Attachment 1

Affected pages from the DAEC UFSAR Chapter 17.2,  
Revision 17, date to be determined.

Discussion of Changes in the  
Quality Assurance Program Description

Mark-up of USFAR Section 13.1,  
"Conduct of Operations"

Figure 13.1-1

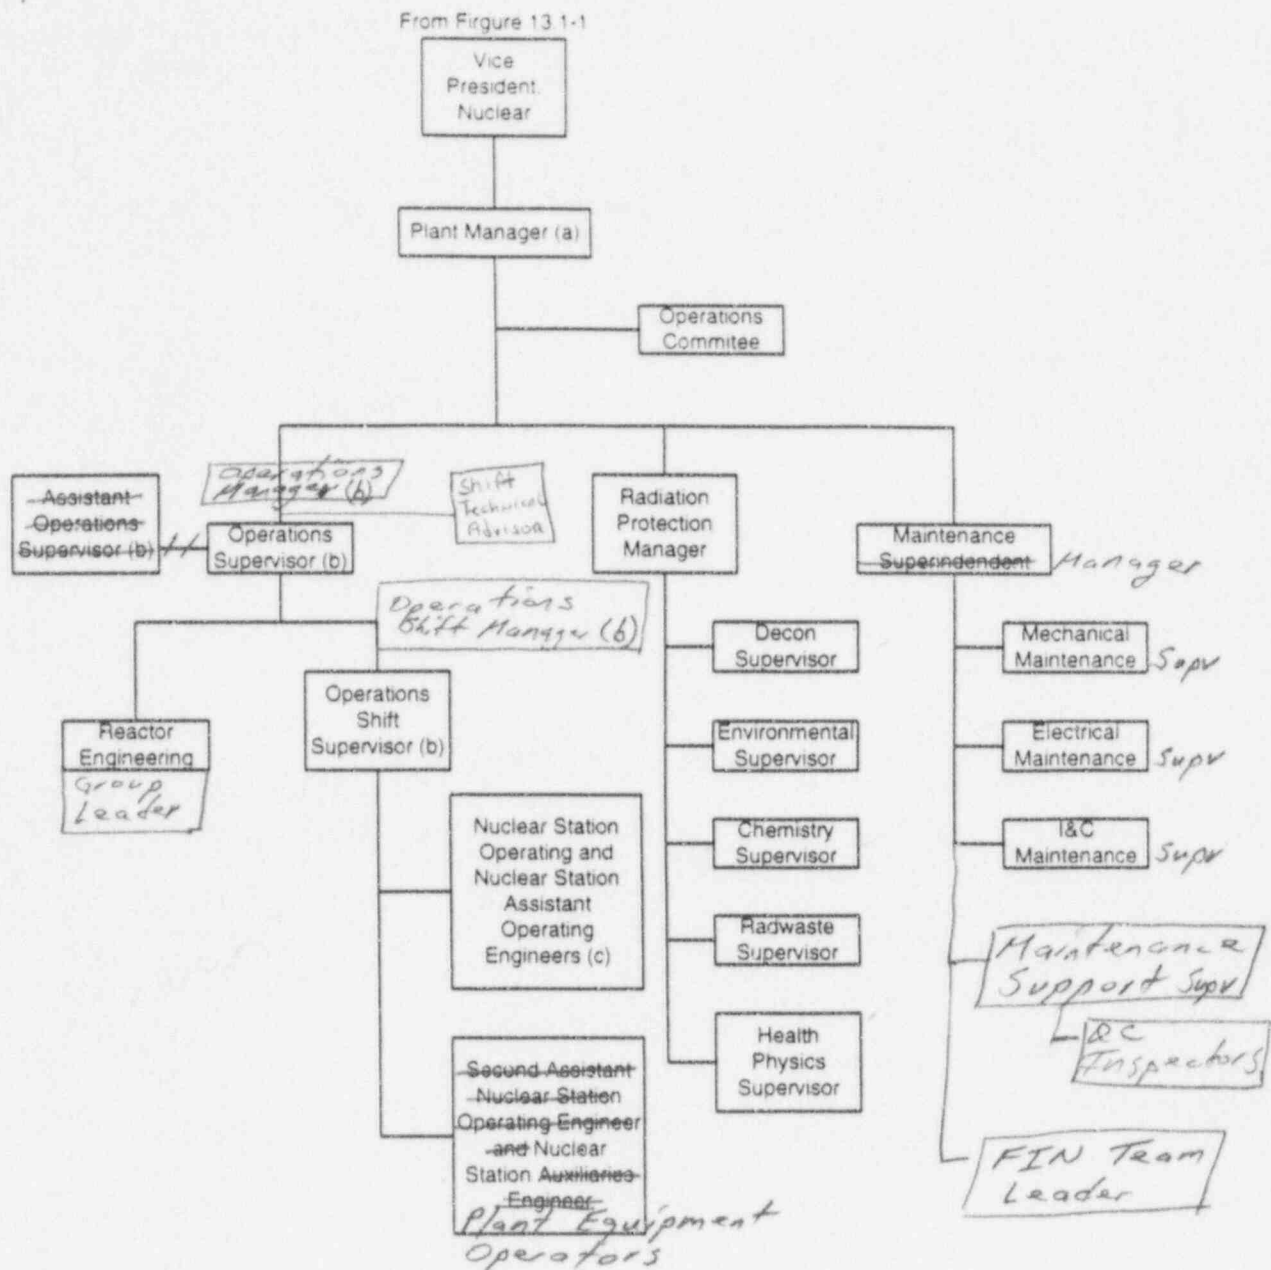
*and*  
The Vice President, Nuclear reports to the President, ~~Chief Operating and Chief Financial~~ Officer. The Nuclear Generation Division Organization is shown in Figure 13.1-1.

To achieve the objective of safe operation of the DAEC, the Nuclear Generation Division has been given specific assignments for operation, engineering, licensing, and emergency planning, and the procurement of nuclear fuel. These responsibilities are distributed among the organizations within the division. These include the Engineering Department, Nuclear Licensing Department, Emergency Planning Department, Nuclear Training Department, Outage and Support Group, Business Unit and the Duane Arnold Energy Center (see Figure 13.1-1).

The Manager, Corporate Quality Assurance, is assigned the primary responsibility for ensuring that quality requirements relative to the safe operation of the DAEC are identified and met. He reports to the Vice President, Nuclear. (See Figure 13.1-1).
